PERMIT
INDEXED
TAX ID #03-343499
ON-SITE SEWAGE DISPOSAL SYSTEM
HOWARD COUNTY HEALTH DEPARTMENT
BUREAU OF ENVIRONMENTAL HEALTH

LOT 3
11825 FREDERICK RD.
ELLICOTT CITY MD

#11825 FREDERICK RD.
LOT 3
MEADOW SPRINGS
TAX MAP 16 GRID 14
PARCEL 283
3RD ELECTION DISTRICT
HOWARD COUNTY, MARYLAND

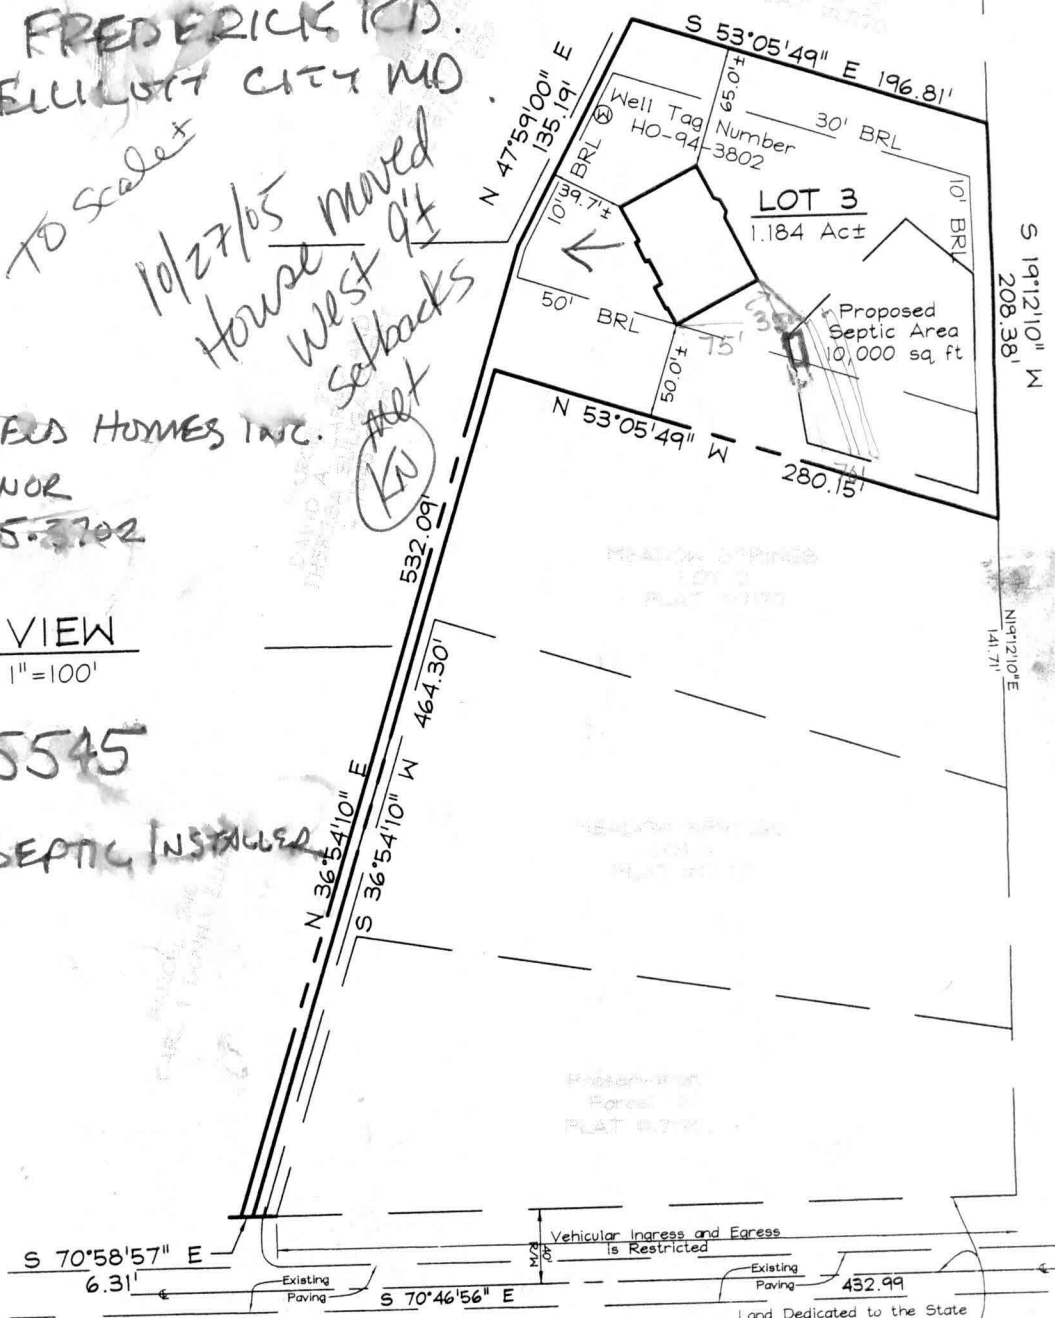
PRE-CONSTRUCTION 3/1/06 Tank set partially in top of septic easement
 Install a short trench of around 35' in top area of easement
 that is left. Then install 2 more longer trenches so
 that 175' trench requirement is met. (BB) 3/2/06 Need house
 connection. O.K. to cover. (BB) 1/19/07 House connection
 verified by builder (Rick Minor) (BB)
